Vehicle Safety Recall - Technical Service Bulletin

Subject: Autocar® ACX with Cummins ISX12G engine and Peterbilt® 320 with Cummins ISX12G engine

Bulletin Date: April 2017

Certain McNeilus Refuse and Rear Discharge Mixer vehicles were built with the incorrect fuel line fitting on a Cummins ISX12G engine CNG fuel filter. An SAE threaded fitting for the fuel line was installed instead of a metric threaded fitting. Installing the incorrect fitting may result in insufficient thread engagement of the fuel line fitting to the CNG engine fuel filter, which could lead to a fuel leak. This bulletin outlines how to replace the incorrect fitting with the correct fitting.

Figure 3

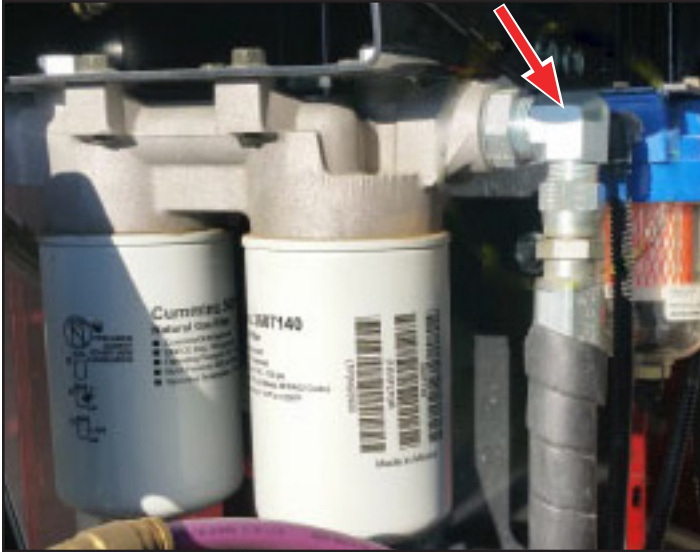
Autocar ISX12G units may have been shipped with a SAE - 12 x #10 JIC 90 fitting at the filter (Figure 3). The SAE - 12 x #10 JIC 90 fitting does not fit into the housing correctly, allowing for a potential slow leak of CNG.

Figure 7

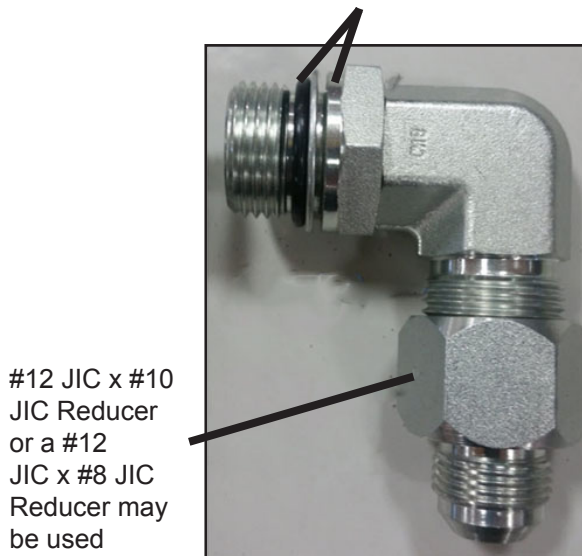
Peterbilt ISX12G units may have been shipped with a brass M27 x 2.0 x #10 JIC 45 or a SAE - 12 x #10 JIC 90 fitting at the filter (Figure 5). Both the brass M27 x 2.0 x #10 JIC 45 and SAE - 12 x #10 JIC 90 fitting do not fit into the housing correctly, allowing for a potential slow leak of CNG. See Figure 7 for an image of the correct fitting.

Correct Fitting for Peterbilt
M27 x 2.0 x #12 JIC

No washer distortion
0 to 2 threads showing
when installed
